Name: Northcrest Village - Preliminary Plan - NE of Hemlock Drive and 7<sup>th</sup> Street

# REVIEW COMMENTS

TITLE HEADING: Preliminary Plan - North Crest  
Village Subdivision

REVIEW COMMENTS

SITE DEVELOPMENT PLAN  
NORTH CREST VILLAGE

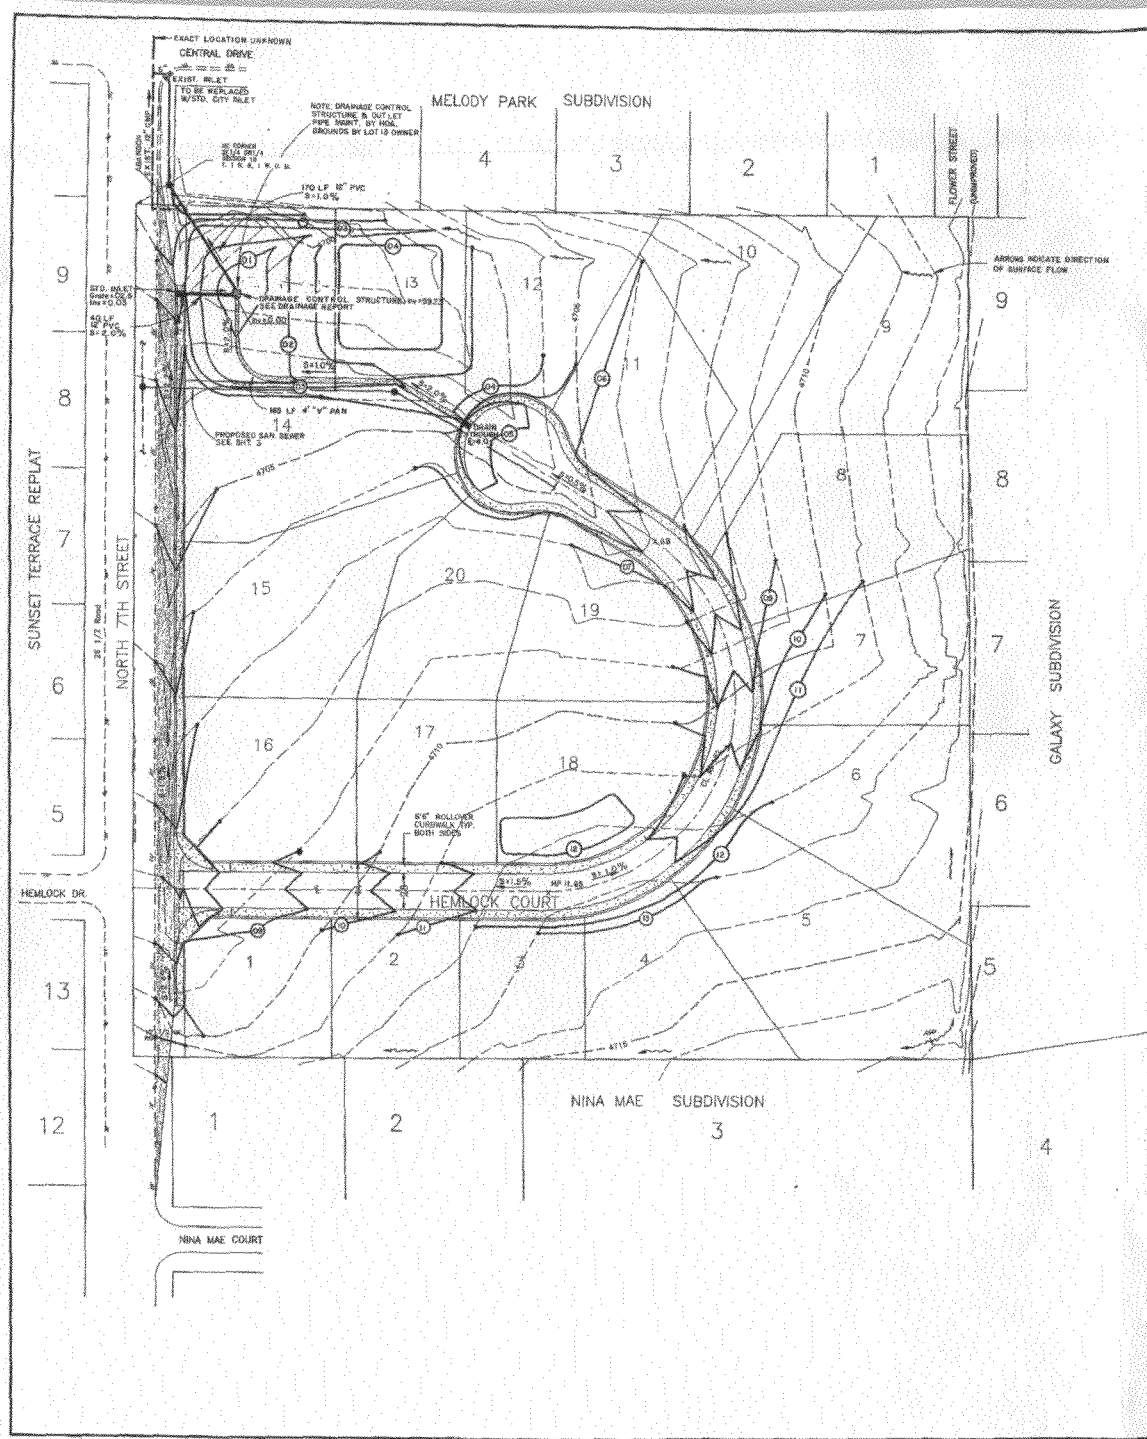
Grand Valley Rural Power would need a 10' easement along the east side of Lot 12.

The fire hydrants are to be placed at the following locations:

At the corner of Hemlock Court & 7th Street  
Between Lots 5 & 6, just back of the sidewalk  
Between Lots 19 & 20, just back of the sidewalk

Want to confirm access to lots 13, 14, 15 is off Hemlock Court and not North 7th Street? If so, is there access off back of lots from 26 1/2 Road? Access to deep lots 5, 9, 10, 13 use of private drives - turnaround for emergency vehicles?

Common access easement should be platted for lots 9 & 10.

A one foot non-vehicular access easement should be platted along 26 1/2 Road to prevent future driveway access. Access restriction and setbacks should be noted on plat.

Site Plan

- P1. Thirty-foot radius curb returns (at the flowline) are required at the intersection of 7th Street and Hemlock. Curbs shall be vertical, with handicap ramps provided.

- P2. From the east end of the curb returns, provide five-foot transitions from vertical to drive-over curb walks.
- P3. For the current irrigation line configurations, additional easements are required on Lots 1, 7, and 16.

- P4. We suggest consideration of an irrigation easement on the north side of Lot 5 for convenient access to the headgate. Depending upon operation procedures, this may not be merited.

- P5,F1. Based upon past discussion by the Planning Commission and City staff, it is strongly recommended that the drainage easement on Lot 13 be made a tract and maintained by the Homeowners Association. If you have concerns about this, please call so we can discuss it.

- F3. Access to lots directly from 7th Street is not allowed. Therefore, immediately east of and adjacent to the east 7th Street R.O.W., a 1.0 foot wide non-vehicular access easement is required, and dedicated to the City.

A 10 foot easement is provided along the east side of Lot 12 on Revised Sheets 2 and 3.

Fire Hydrants have been relocated as requested and are shown on Revised Sheet 2.

A one foot Non-Vehicular Access Easement has been added to Revised Sheet 2 which will prohibit direct driveway access to Seventh Street from Lots 1, 14, 15, and 16. Since the access drive for Lots 9 and 10 is slightly longer than 100 feet it is felt that a turn-around would not be necessary.

The following changes have been made to Revised Sheet 2, Site Development Plan:

1. A thirty foot radius curb return at the flowline and five foot transition at the intersection of proposed Hemlock Court and Seventh Street. The intersection improvements will be constructed in accordance with City Standards depicted on Exhibit "G", *Accessible Ramp and Parking Stall Details*.
2. Easement for all proposed irrigation system improvements including a 5 foot easement along the south side of Lot 6.
3. In order to insure on-going maintenance of the grounds within the stormwater detention area a drainage easement is described across a portion of the west half of Lot 13. The owner of Lot 13 will be responsible for the care and use of the area within the easement. The Homeowners Association will be responsible for the operation and maintenance of the drainage control structure and related piping within the easement.

A Ingress and Egress Easement for Lots 9 and 10 has been added to Revised Sheet 2.

A one foot non-vehicular access easement has been added to Revised Sheet 2.
